United States Patent and Trademark Office

APPLICATION NO.	FILING DATE	FIRST NAMED INVENTOR	ATTORNEY DOCKET NO.	CONFIRMATION NO.
10/638,849	08/11/2003	James Xixian Wu	SP-1076.2 US	4449
20875	7590 06/13/2005		EXAMINER	
ROBERT W WELSH EVEREADY BATTERY COMPANY INC			CANTELMO, GREGG	
25225 DETROIT ROAD			ART UNIT	PAPER NUMBER
P O BOX 450777			1745	
WESTLAKE, OH 44145		DATE MAILED: 06/13/2005

DETAILED ACTION

FIG. 1 OF THE INSTANT APPLICATION

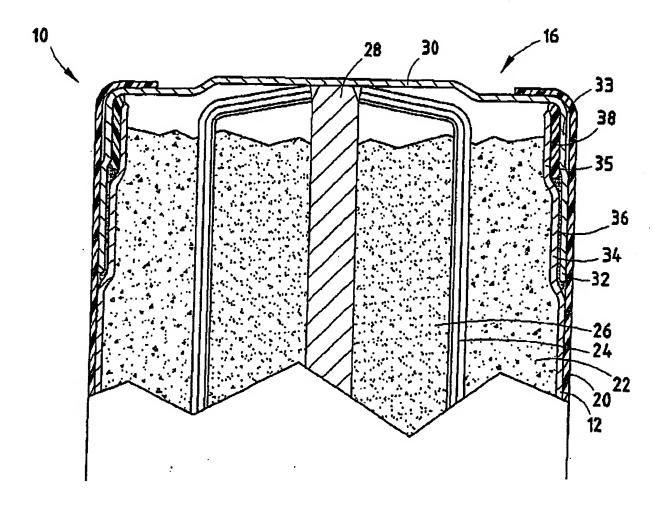
Applicant's own disclosure of to Fig. 1 shows that the cover 30 which is cupshaped having bent edges is placed in a sealing arrangement with the container. The disclosure of Riedl is identical to this arrangement as claimed (discussed above). A complete review of the original disclosure of the instant application reveals that Applicant's own disclosure recognizes this arrangement to be exemplary of a non-crimped design (see Fig. 1 and paragraph bridging pages 6 and 7 of the instant Applications own disclosure).

Provided herein is a side-by-side comparison between Fig. 1 of the instant application, an admitted embodiment of a non-crimped arrangement between the cover and container of a battery and Fig. 3 of Riedl.

In Fig. 1 of the instant application, reference character 30 corresponds to the cover and 12 to the container. As described in the paragraph bridging pages 6 and 7 of

the instant application, this arrangement is a non-crimped arrangement between the cover 30 and container 12.

FIG. 3 of RIEDL

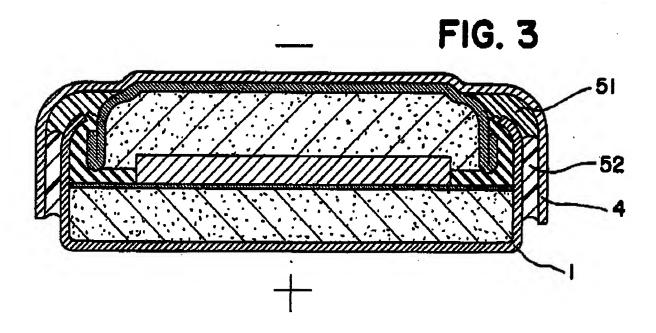
the container. Neither the peripheral wall of the cover 4 nor the open end of the container 1 is crimped (Fig. 3 as applied to claim 1).

A seal 52 is disposed between the sidewall of the container and the peripheral wall of the cover (Fig. 3 as applied to claim 2).

First adhesive 51 is closer to the open end of the container 1 and the second adhesive 52 is located further away from the open end of the container (Fig. 3 as applied to claim 4).

The Examiner maintains the position that the structure in Figs. 2 and 3 shows a non-crimped structure relationship between the cover 4 and container 1

In Fig. 3 of Riedl, reference character 4 corresponds to the cover and 1 to the container. This arrangement, structurally identical to the cover and container arrangement with respect to the claimed invention is also understood to be non-crimped arrangement between the cover 4 and container 1.

It should be apparent for the reasons set forth above, and from the analysis of the corresponding figures below, that the prior art in fact anticipates the non-crimped structure. Therefore the rejection stands.
